## AMENDMENT 2

- 2 BUNGALOW HOMES ADDED
- N. QUEMOY CT. EXTENDED NORTH
- BUFFER LANDSCAPE ALONG PICADILLY PHASED

GREEN VALLEY RANCH EAST  
PRELIMINARY SITE PLAN #5  
TITLE: KEYMAP  
DATE: March 8, 2023

TYPICAL BUNGALOW 6-PACK  
LANDSCAPE

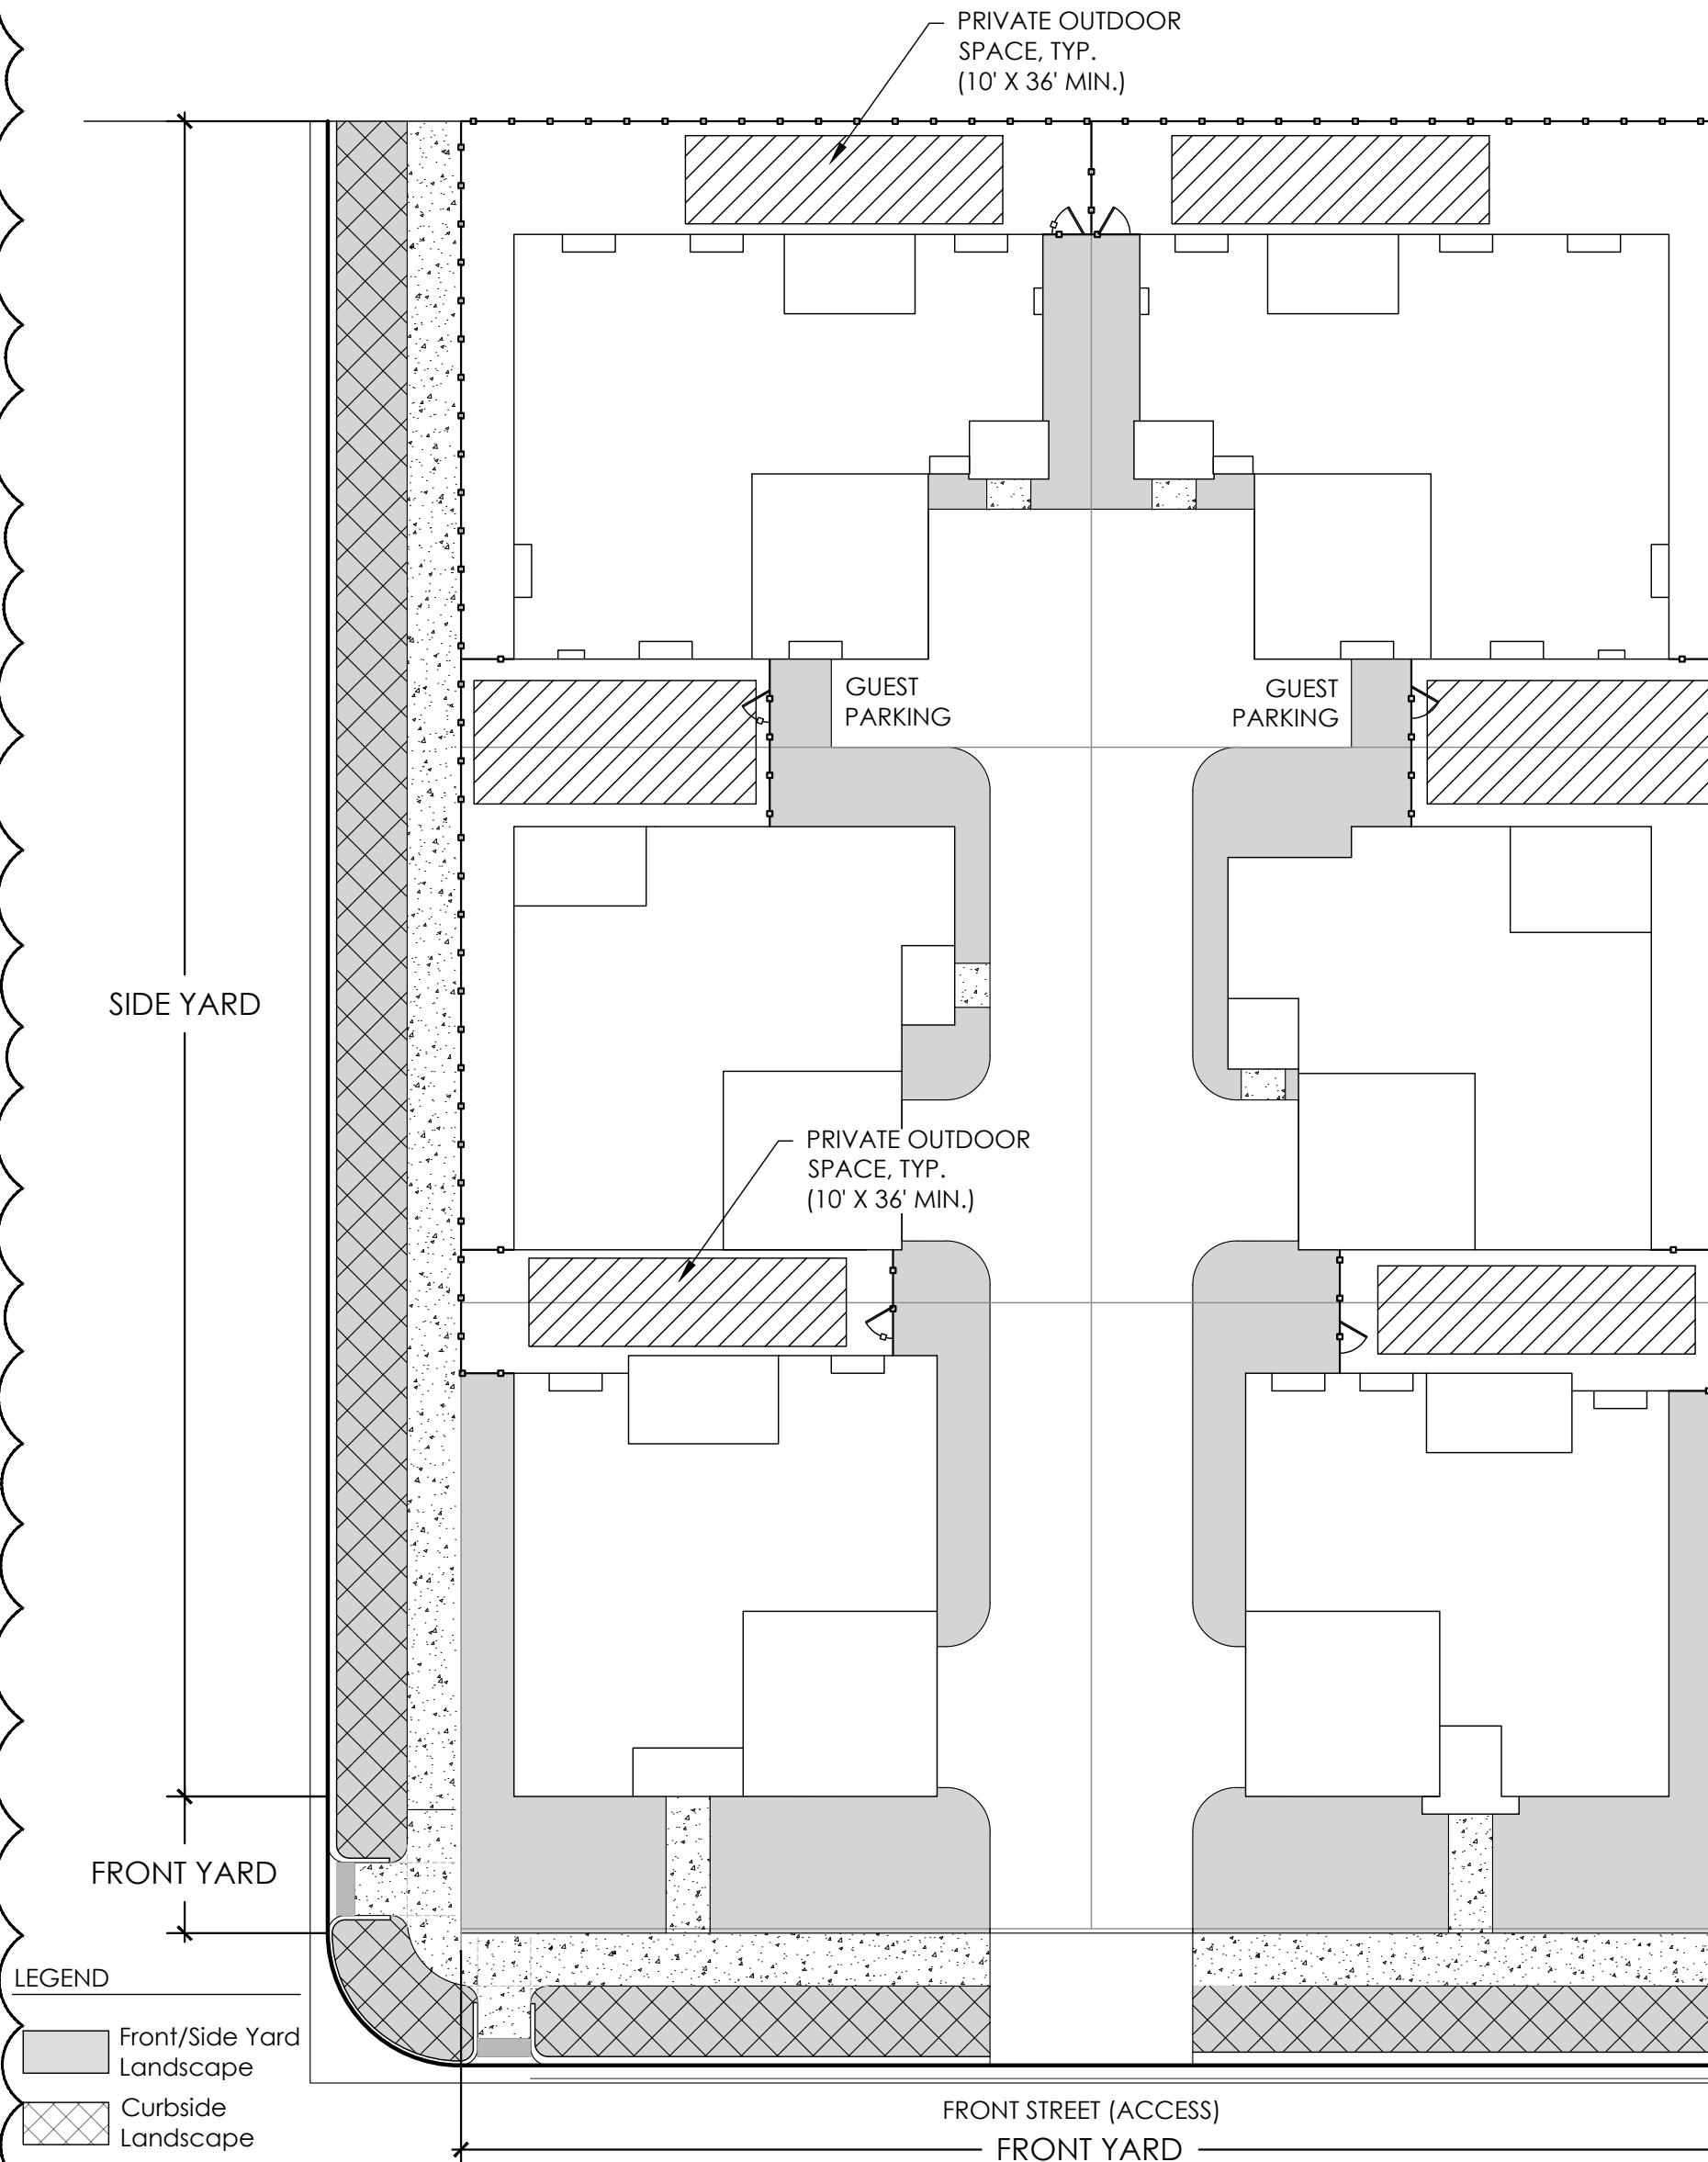
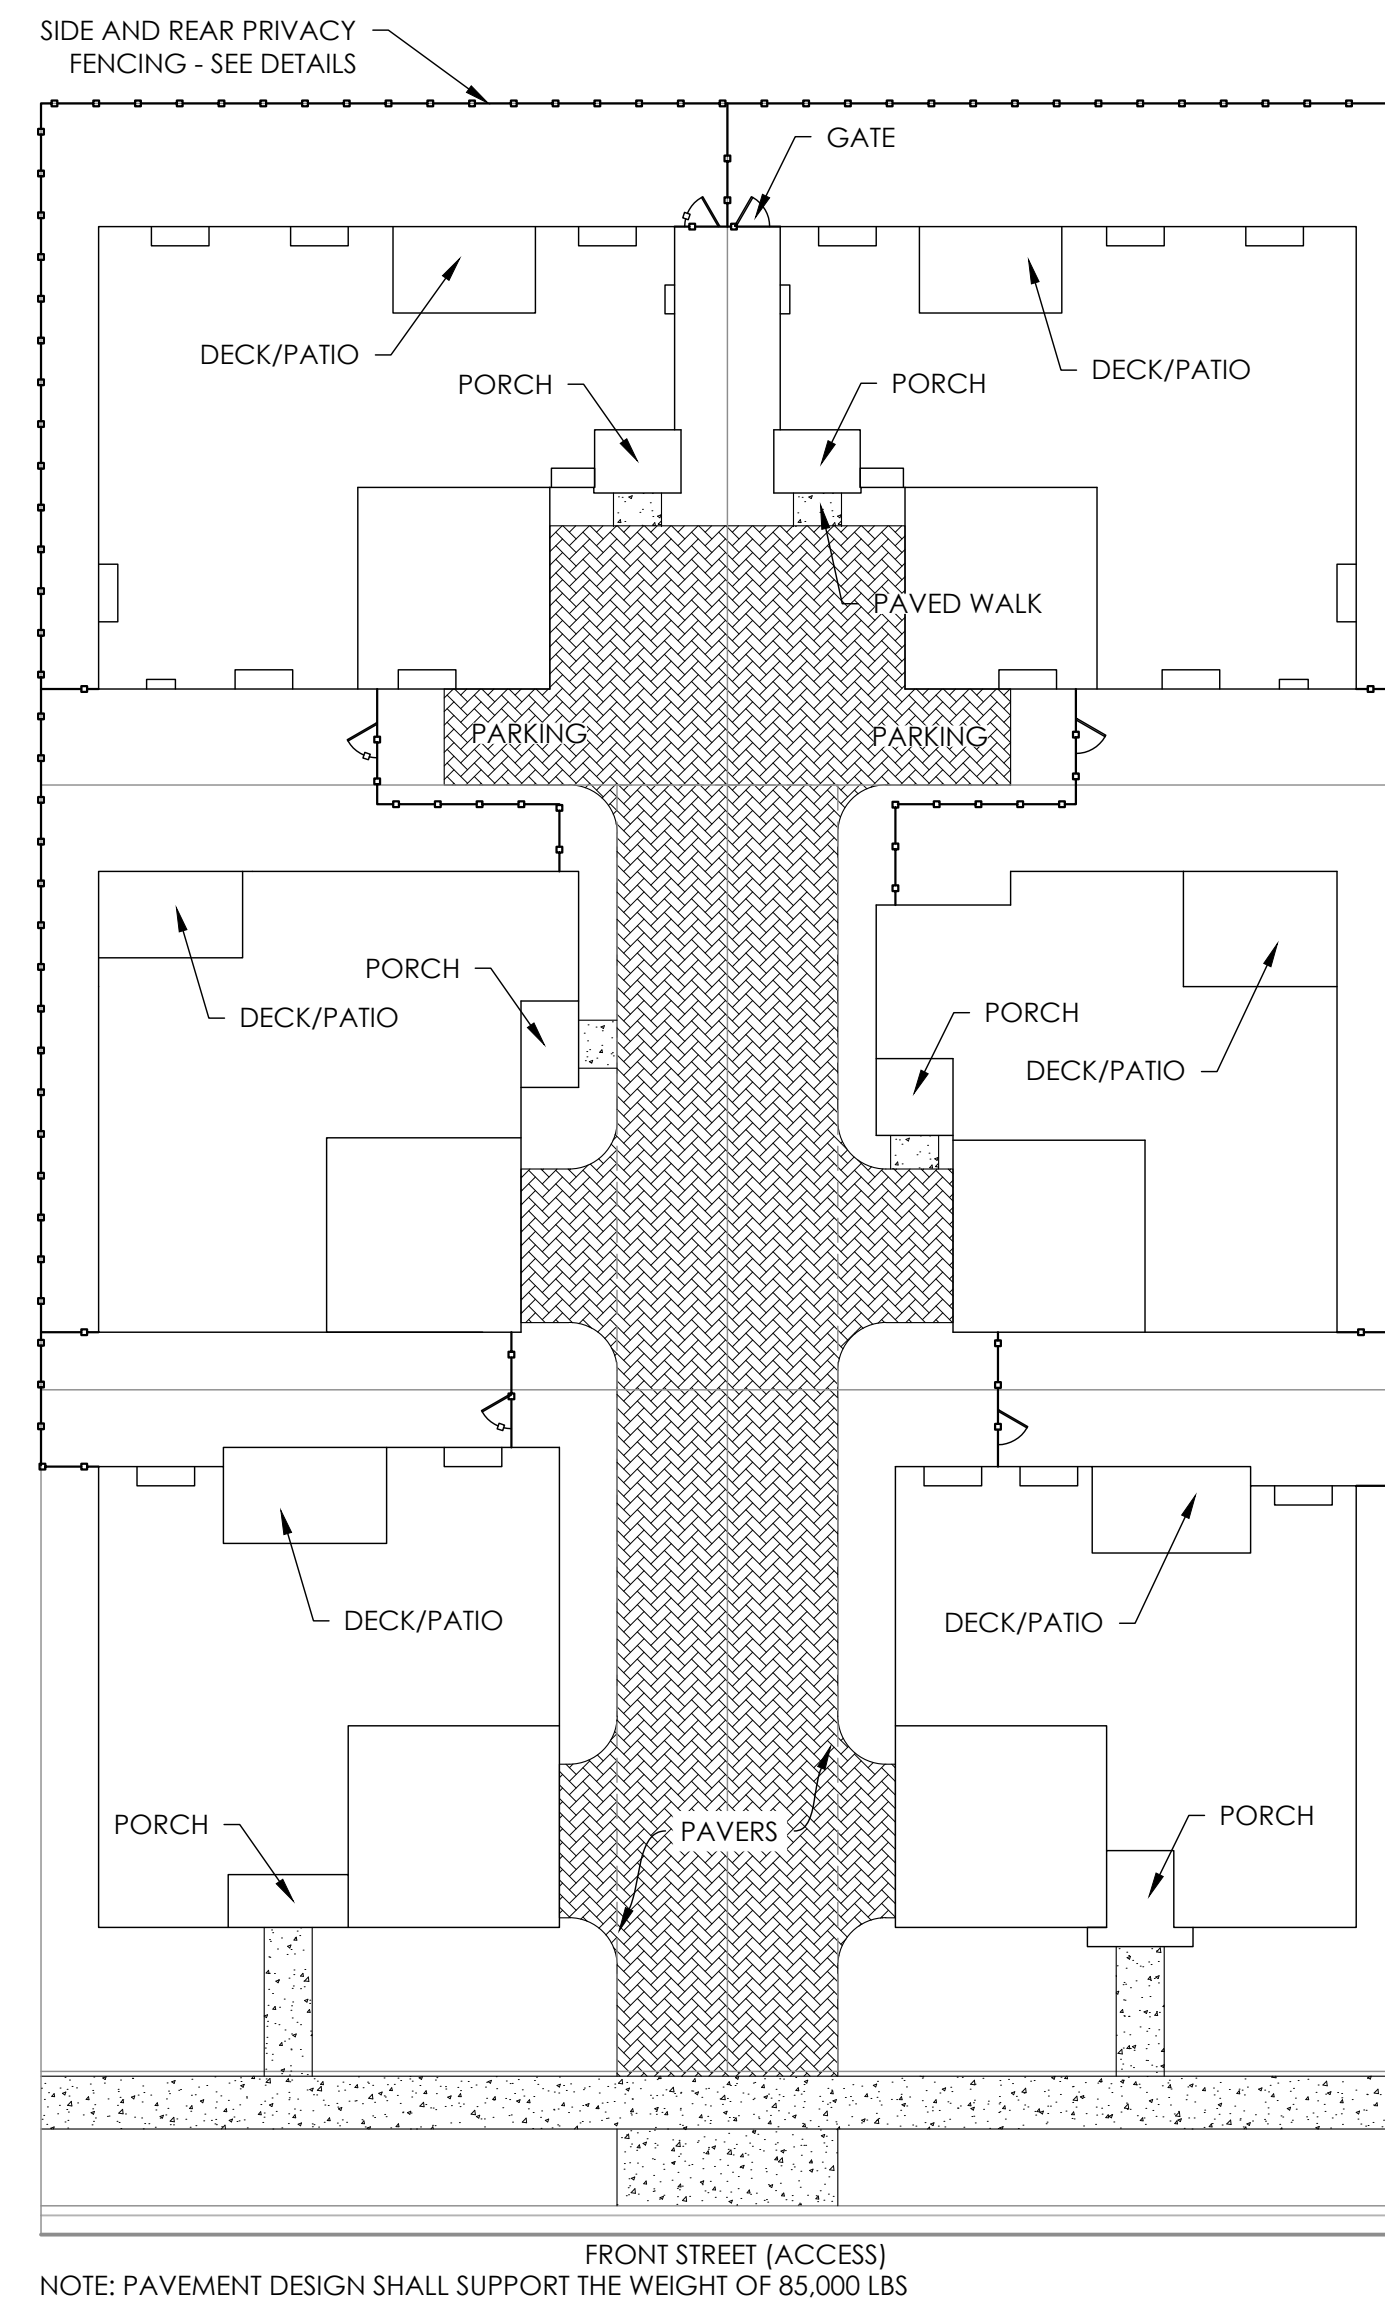
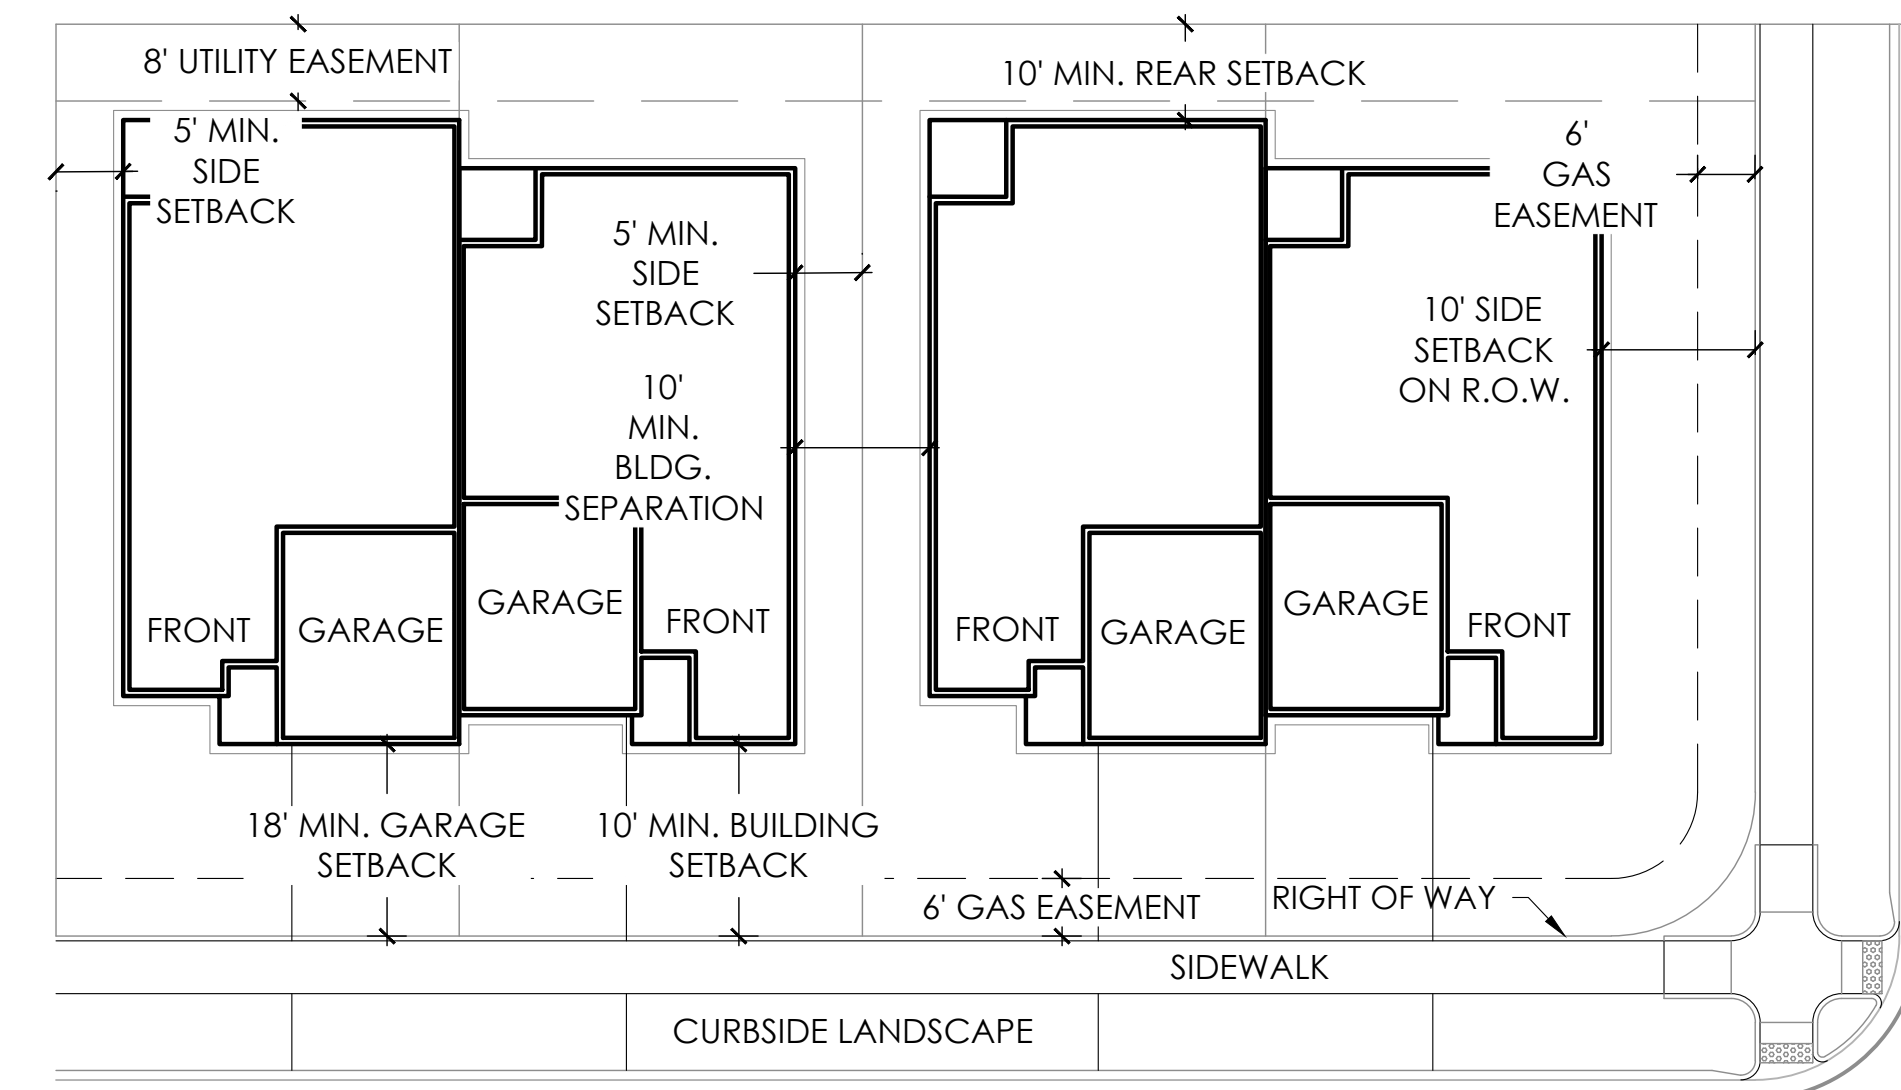
1  
AMENDMENT 1  
- BUNGALOW 6 PACK TYPICALS ADDED

3  
AMENDMENT 3  
- ADDED FRONT LOADED DUPLEX SETBACK AND EASEMENT TYPICAL
